The Summit at Ski Lake No. 12

A part of the Northeast Quarter of Section 24, T6N, R1E, SLB & M, U.S. Survey
Weber County, Utah
February 2013

REVIEWED
By Michael Tuttle at 4:58 pm, Sep 12, 2013

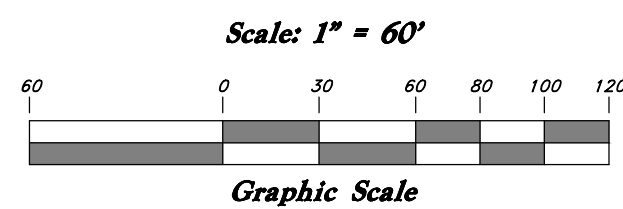
There should probably be a note that the lots on the downhill side of the road will accept the water off the roadway unless the design changes to have swales on both sides of the road.

Where does the PUE change to just a 20' sewer easement?

Is there some road slope that should have an easement along here?

Is it possible to show the dimensions so we can locate the easements without having to redraw the recorded written easement?

Should there be a no access line for these lots with double frontage?
